Groundwater Application Review Summary Form

Application # G- 19000

GW Reviewer Ben Scandella, Jen Woody Date Review Completed: 11/15/2021

A. GENERAL INFORMATION: Applicant's Name: City of Scappoose County: Columbia

Well interference modeling results. Units for T are ft²/day

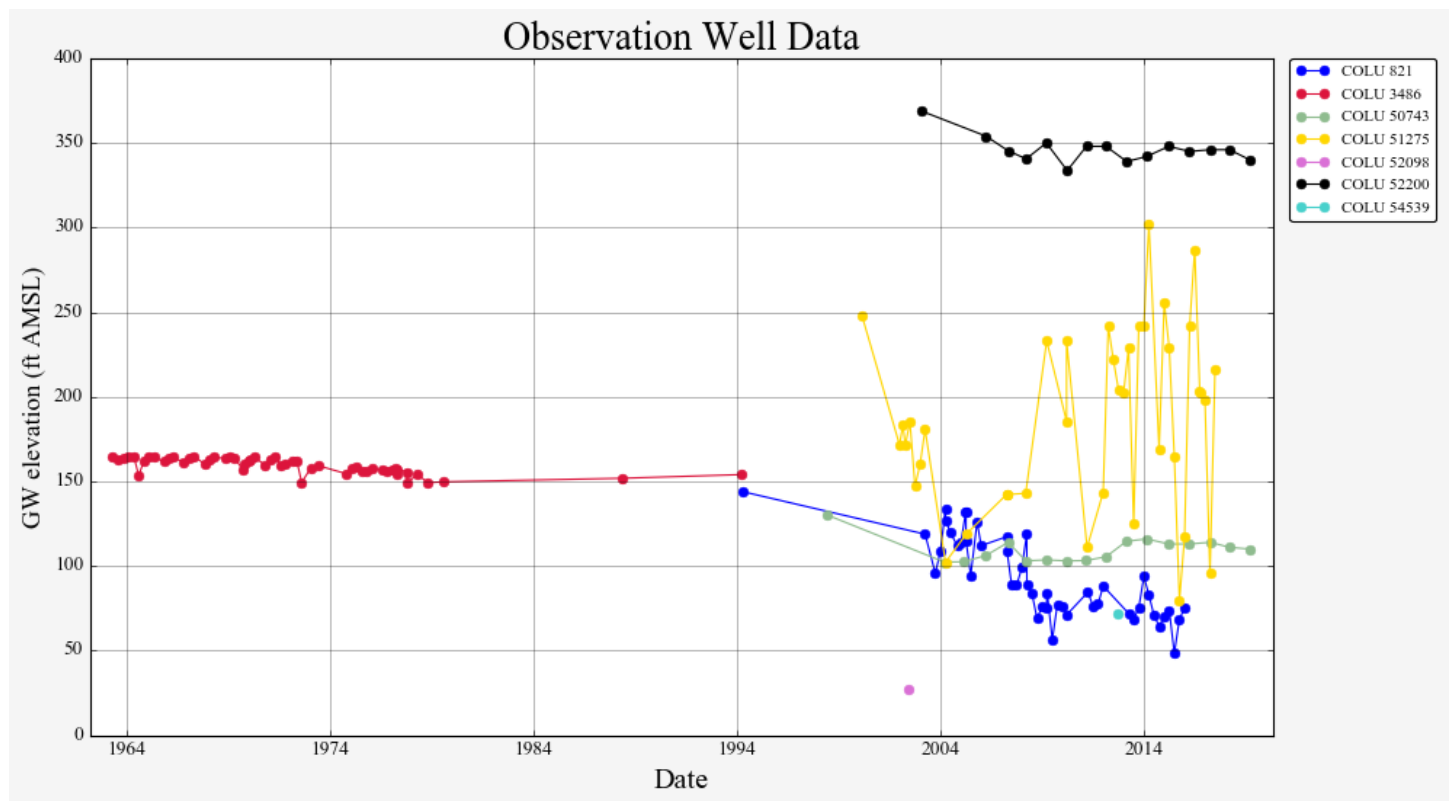
The nearest well known to access basalt is COLU 52098, just over 1 mile west of the subject wells. The potential for interference with this well from the proposed use was modeled using the Theis, (1935) equation for drawdown in a confined aquifer and parameters from nearby pumping tests (see Theis Drawdown Analysis below). Results indicate that the proposed use would cause well-to-well interference with COLU 52098 likely limited to less than 15 feet over 6 months of continuous pumping at the maximum proposed rate (0.8 cfs) from Well #3. Therefore, the conditions proposed above should avoid injury to other groundwater users and to the groundwater resource.

This is drawdown at $r = 6000$ ft from pumping well
